Required Parts Kit

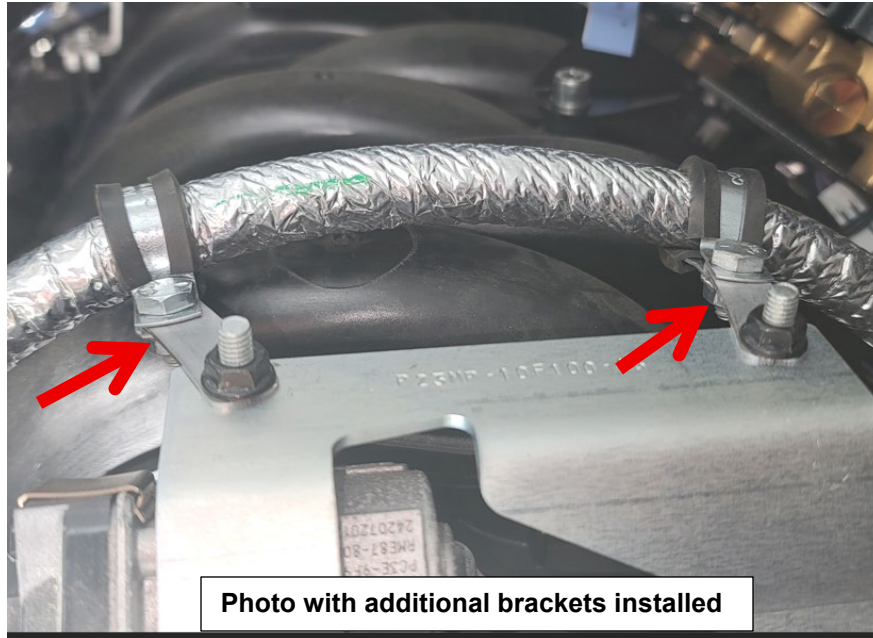
1 Remove the 2 nuts from the Front Crossover Fuel Line retention bracket.

- 2** Add the 2 additional brackets to move the 2 P clamps holding the Front Crossover Fuel Line towards the rear of the engine. Align the additional brackets until proper clearance between the Front Crossover Fuel Line and the alternator is obtained, then tighten the fasteners in place at 10 NM +/-2.

- 3** Apply the foil wrapped protective cover with 2 high temp plastic ties to the concerned area of the Front Crossover Fuel Line as a precautionary measure.
